## Model Error Resolution Document

1. Document Number:	MDL-NBS-HS-000008	2. Revision/Addendum:	02/01	3. ERD:	02
---------------------	-------------------	-----------------------	-------	---------	----

4. Title:	Radionuclide Transport Models Under Ambient Conditions
-----------	--

## MDL-NBS-HS-000008 ERD 02 Corrections

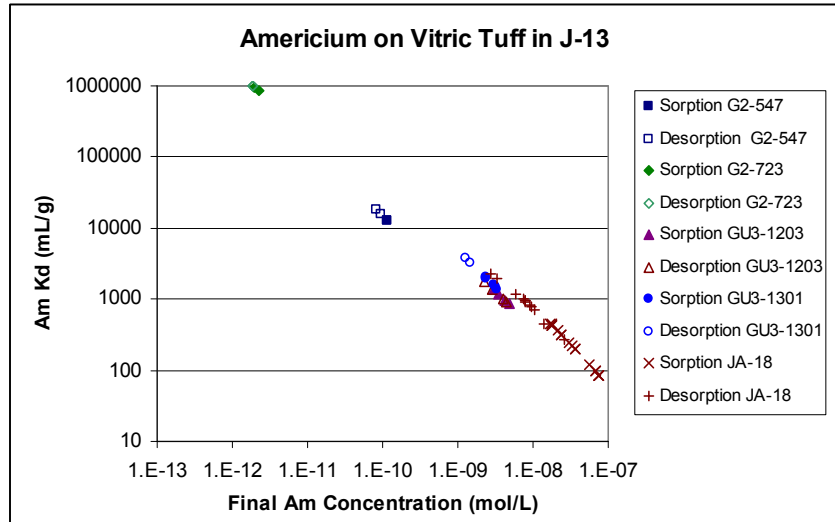
6. In REV 02 on page A-74, replace Figure A-59d with Figure A-59d[b] of this ERD. Correct the caption by replacing “Strontium” with “Thorium”. Replace the superseded DTN cited between the figure and the caption with: “DTN: LA0803AM831341.001 [DIRS 185573]”.

Figure A-7[b]. Americium Sorption Coefficients on Vitric Tuff versus Calculated Final Americium Concentration in Solution

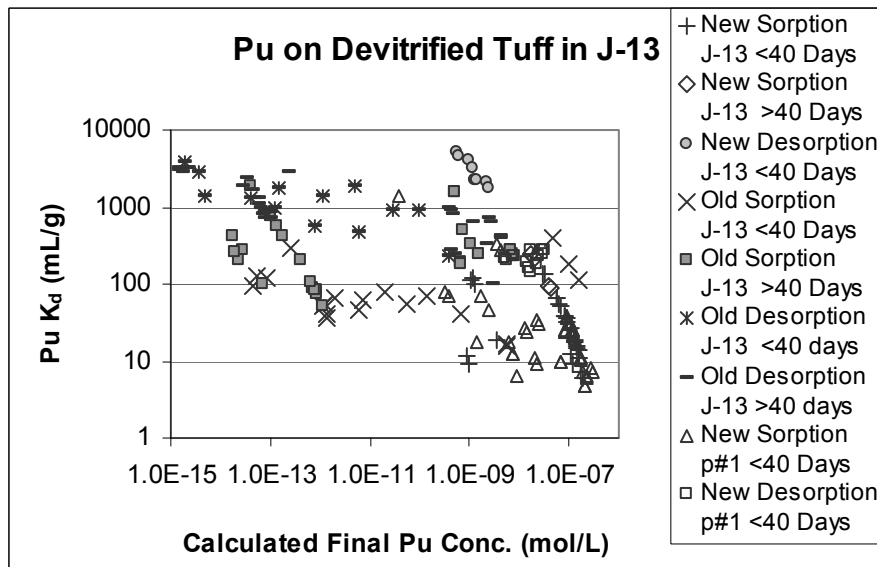
5. In REV 02 on page A-18, Figure A-7, replace with Figure A-7[b] of this ERD. Do not replace the caption. Replace the superseded DTN cited between the figure and the caption with: “DTN: LA0803AM831341.001 [DIRS 185573]”.

Figure A-28[b]. Plutonium Sorption Coefficients on Devitrified Tuff versus Calculated Final Plutonium Concentration in Solution

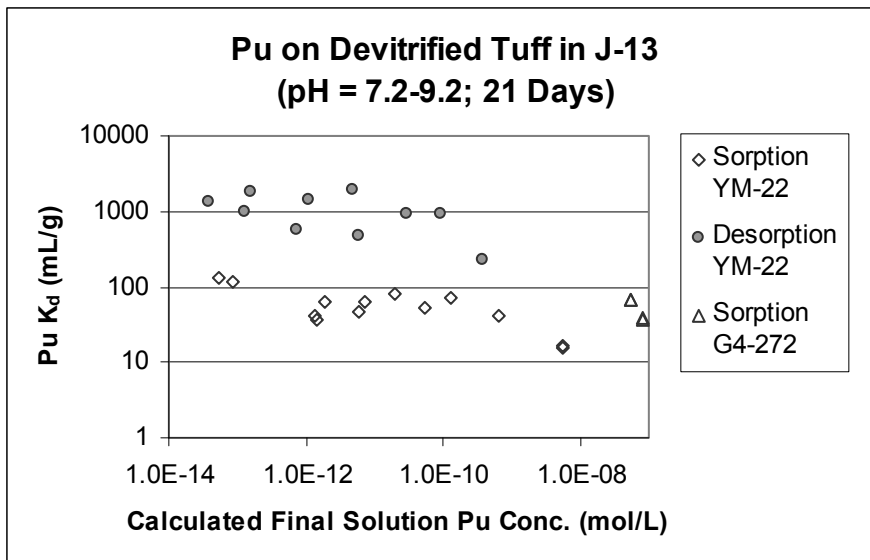
1. In REV 02 on page A-39, Figure A-28, add two “New Desorption J-13 <40 Days” circle points corresponding to final Pu concentrations of  $1.35\text{E-}09$  and  $1.33\text{E-}09$  mol/L with  $K_d$  values of 2239.5 and 2307.4 mL/g, respectively. In the same figure, add two “New Sorption J-13 <40 Days” plus-symbol points corresponding to final Pu concentrations of  $8.75\text{E-}08$  and  $9.24\text{E-}08$  mol/L with  $K_d$  values of 35.3 and 32.8 mL/g, respectively. These changes are captured in Figure A-28[b] of this ERD.

Figure A-29[b]. Plutonium Sorption Coefficient versus Calculated Final Plutonium Solution Concentration in Moles/Liter for Experiments with Samples YM-22 and G4-272

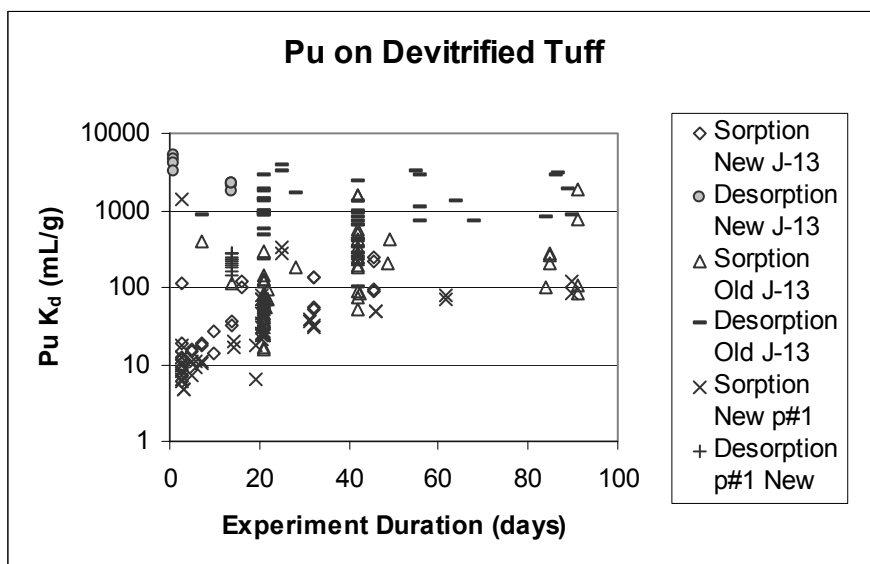
2. In REV 02 on page A-40, Figure A-29, remove the desorption data points for sample G4-272. No desorption data were found in the revised DTNs for sample G4-272 that specifies 21-day test durations and J-13 solution. These changes are captured in Figure A-29[b] of this ERD.

Figure A-30[b]. Plutonium Sorption Coefficient on Devitrified Tuff versus Experiment Duration for Sorption (Forward) and Desorption (Backward) Experiments

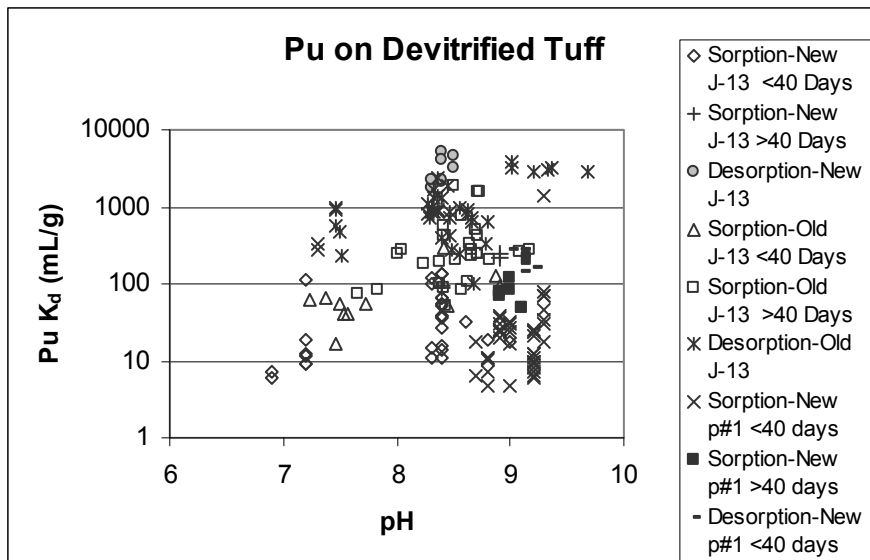
3. In REV 02 on page A-41, Figure A-30, add two “Desorption New J-13” circle points corresponding to 13.94 days with  $K_d$  values of 2239.5 and 2307.4 mL/g. In the same figure, add two “Sorption New J-13” diamond points corresponding to 13.72 days with  $K_d$  values of 35.3 and 32.8 mL/g. Also, remove “in J-13” from chart title. These changes are captured in Figure A-30[b] of this ERD.

Figure A-31[b]. Plutonium Sorption Coefficient on Devitrified Tuff in J-13 and Synthetic p#1 versus Solution pH in Sorption (Forward) and Desorption (Backward) Experiments

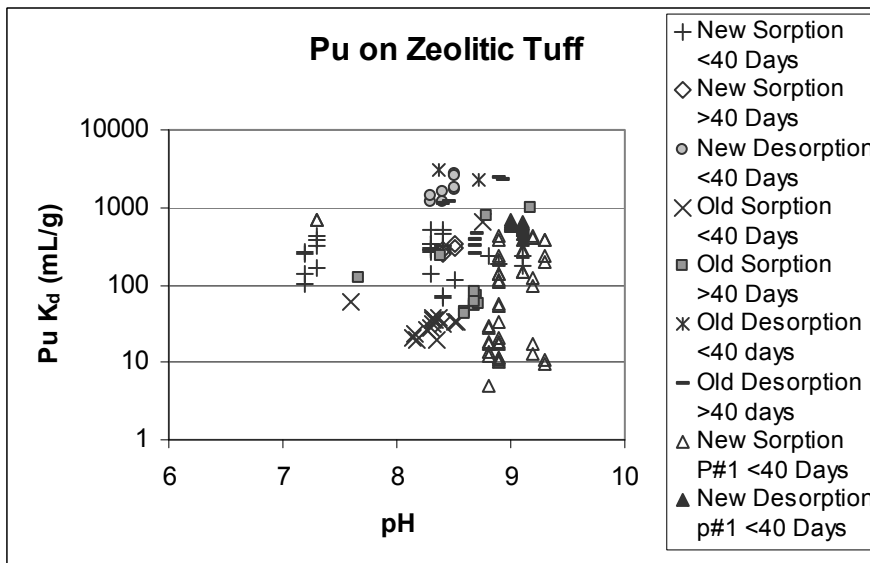
4. In REV 02 on page A-41, Figure A-31, add two “Desorption-New J-13” circle points corresponding to pH 8.3 and 8.4 with  $K_d$  values of 2239.5 and 2307.4 mL/g, respectively. In the same figure, add two “Sorption-New J-13 <40 Days” diamond points corresponding to pH 8.4 and 8.6 with  $K_d$  values of 35.3 and 32.8 mL/g, respectively. These changes are captured in Figure A-31[b] of this ERD.

Figure A-36a[b]. Plutonium Sorption Coefficient on Zeolitic Tuff in J-13 and Synthetic p#1 versus Solution pH in Sorption (Forward) and Desorption (Backward) Experiments with Durations Greater than 40 Days

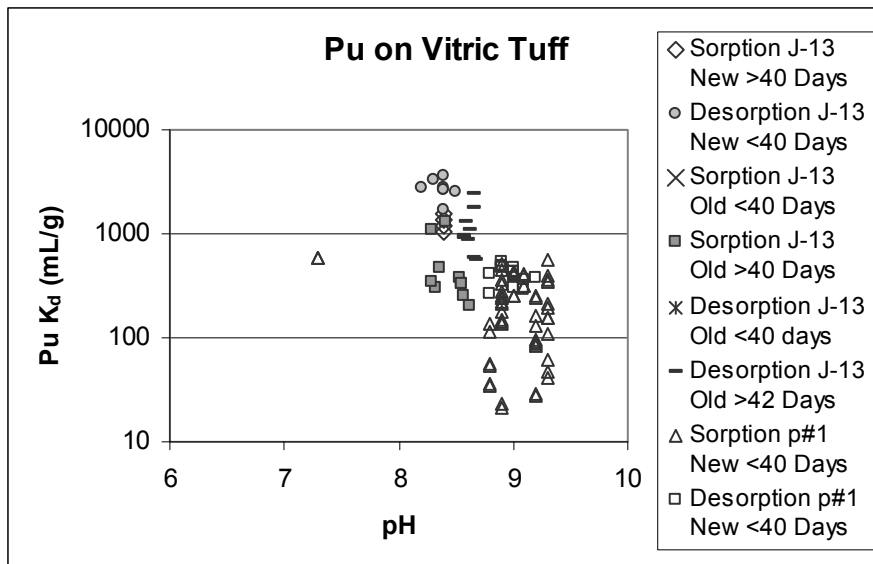
5. In REV 02 on page A-46, Figure A-36a, remove two “New Desorption <40 Days” circle points corresponding to pH 8.3 and 8.4 with  $K_d$  values of 2239.5 and 2307.4 mL/g, respectively. In the same figure, remove two “New Sorption <40 Days” plus-symbol points corresponding to pH 8.4 and 8.6 with  $K_d$  values of 35.3 and 32.8 mL/g, respectively. These changes are captured in Figure A-36a[b] of this ERD.

Figure A-39a[b]. Plutonium Sorption Coefficient on Vitric Tuff in J-13 and Synthetic p#1 versus Solution pH in Sorption (Forward) and Desorption (Backward) Experiments with Durations Greater than 40 Days

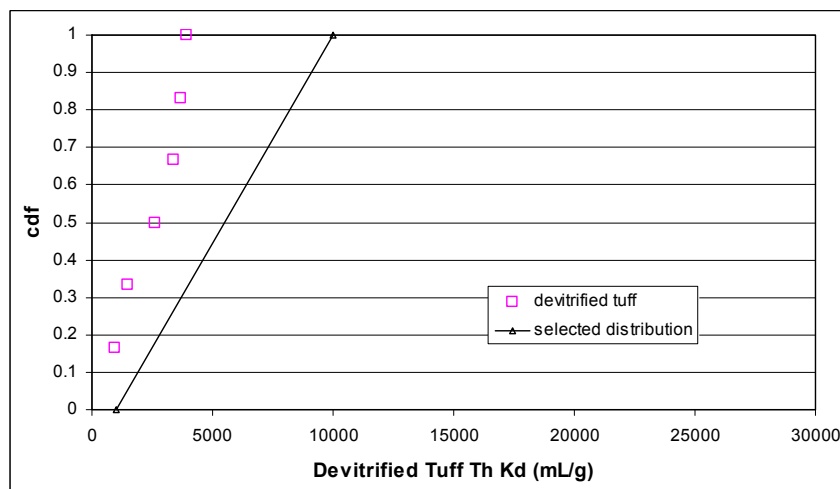
6. In REV 02 on page A-49, Figure A-39a, remove plus-sign data points between pH values of 7 and 7.5. These data could not be located. These changes are captured in Figure A-39a[b] of this ERD.

Figure A-59b[b]. Empirical Cumulative Distribution for Thorium Sorption Coefficients on Devitrified Tuff

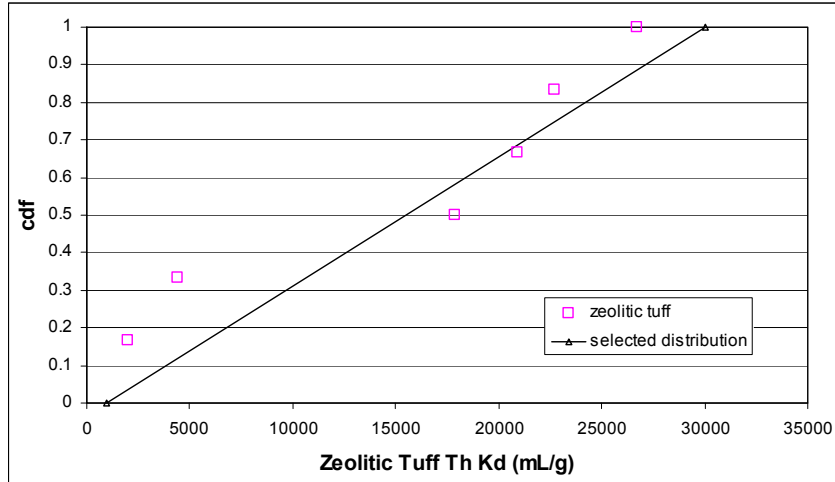
4. In REV 02 on page A-73, replace Figure A-59b with Figure A-59b[b] of this ERD. Correct the caption by replacing “Strontium” with “Thorium”. Replace the superseded DTN cited between the figure and the caption with: “DTN: LA0803AM831341.001 [DIRS 185573]”.

The only corrections where a negligible impact is not obvious involve the thorium  $K_d$  distributions (CR 11020). A rock-type correction for sample G1-3116 caused the two highest thorium  $K_d$  measurements to move from devitrified (Figure A-59b) to zeolitic (Figure A-59c). As a result, the selected  $K_d$  distribution for devitrified tuff in Figure A-59b is non-conservative compared to the data (Figure A-59b, Attachment A of this ERD), i.e., it overestimates the thorium  $K_d$  for devitrified tuff by a factor of as much as 2.5, which underestimates the mobility of thorium. (The impact to the zeolitic distribution is negligible, as shown in Figure A-59c of Attachment A.) In addition, an unrelated correction was made to Figure A-59d for vitric tuff (see Figure A-59d of Attachment A). This figure (Figure A-59d) was found to display one too many vitric tuff  $K_d$  values, so it is replaced with Figure A-59d of Attachment A. While this correction did not markedly change the distribution of data for vitric tuff, it was noted that the selected distribution for vitric tuff appears to be even more non-conservative than the distribution selected for devitrified tuff. For vitric tuff, the maximum of the selected distribution is five times the maximum measured value.

Figure A-59c[b]. Empirical Cumulative Distribution for Thorium Sorption Coefficients on Zeolitic Tuff

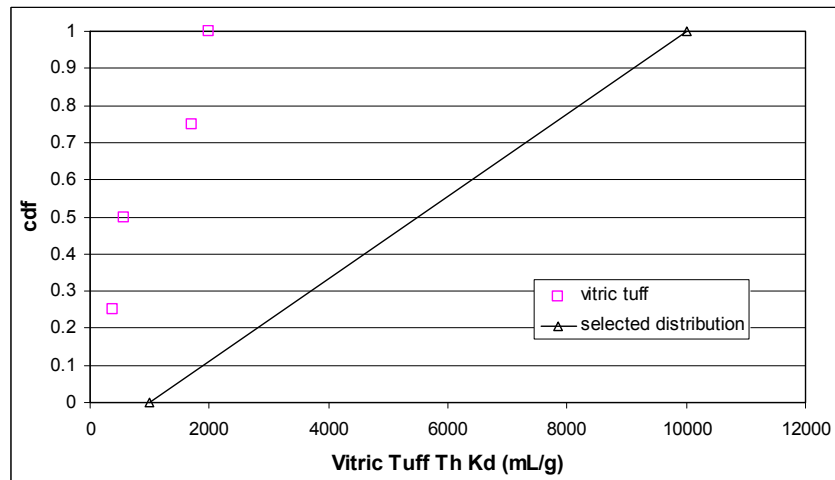
5. In REV 02 on page A-74, replace Figure A-59c with Figure A-59c[b] of this ERD. Correct the caption by replacing “Strontium” with “Thorium”. Replace the superseded DTN cited between the figure and the caption with: “DTN: LA0803AM831341.001 [DIRS 185573]”.

Figure B-1. Empirical Cumulative Distributions for Thorium Sorption Coefficients on Devitrified Tuff

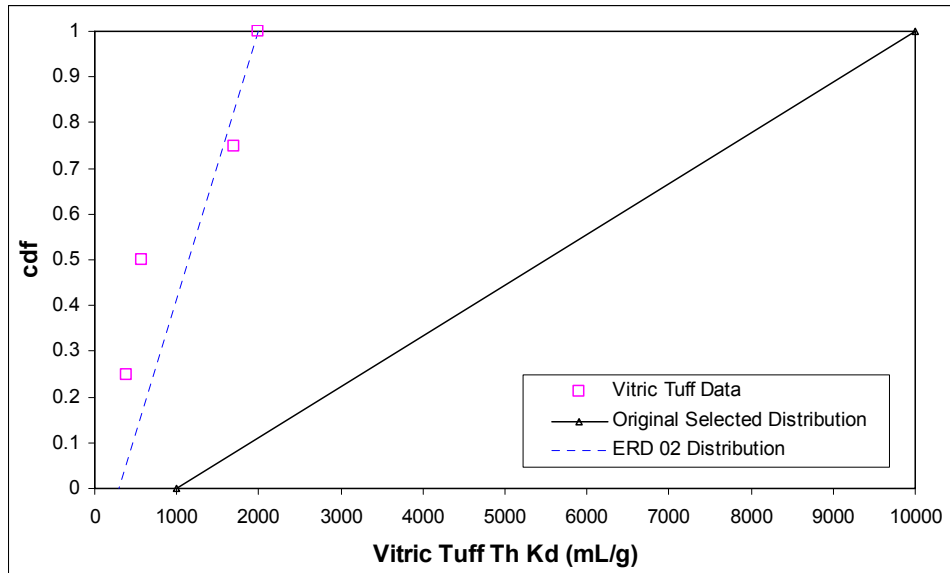
Therefore, new thorium  $K_d$  distributions were developed for a TSPA impact analysis to determine whether there is an impact to repository performance. These new distributions are referred to as “modified”  $K_d$  distributions because they do not supersede the original selected distributions. The modified distributions are presented in Table B-1 and compared to the data and original selected distributions in Figures B-1 and B-2. The modified distribution is unchanged for zeolitic tuff because the original selected distribution remains representative, as shown in Figure A-59c of Attachment A of this ERD. These modified distributions of thorium  $K_d$  values are documented in DTN: LA0809SL831341.001. The direct input is source DTN: LA0803AM831341.001 [DIRS 185573].

Species	Unit/Analysis	Distribution	Coefficients describing distribution (mL/g)
Th	Zeolitic	Uniform	Range = 1,000 - 30,000 (no change)
	Devitrified	Uniform	Range = 900 - 4,000
	Vitric	Uniform	Range = 300 - 2,000
